SERVICE BULLETIN CREF20070202
LG Electronics Monterrey México

Code: SB-07-011
Date of Issue: Mar 27, 2007

Factory Model: Refer to page 3
Buyer Model: Refer to page 3
Buyer Name: Refer to page 3 Effective Date: Mar 23, 2007
Serial Number: 703MR*****
Subject: Compressor Damper standardization
Total pages including cover (qty): 3

Reason of change:
Standardization of compressor damper.

● Exploded View from Service Manual

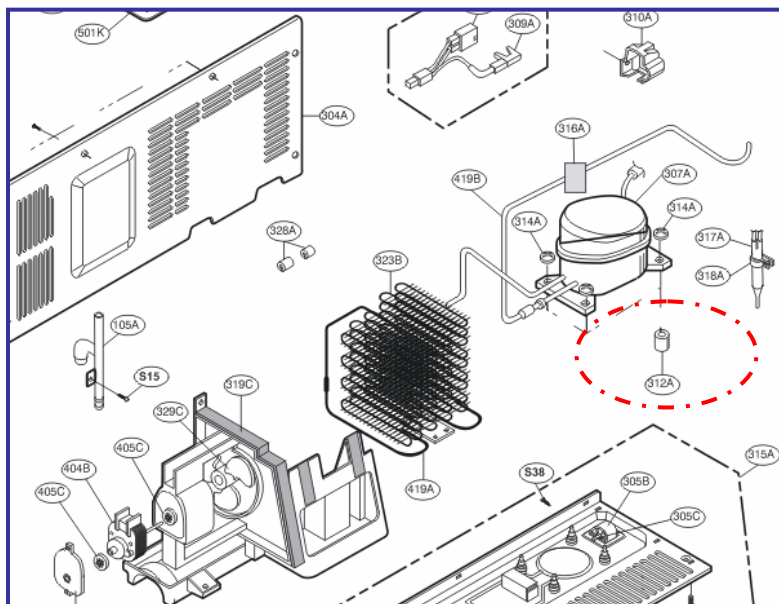
BEFORE

5040JA3071A

AFTER

5040JA3073A
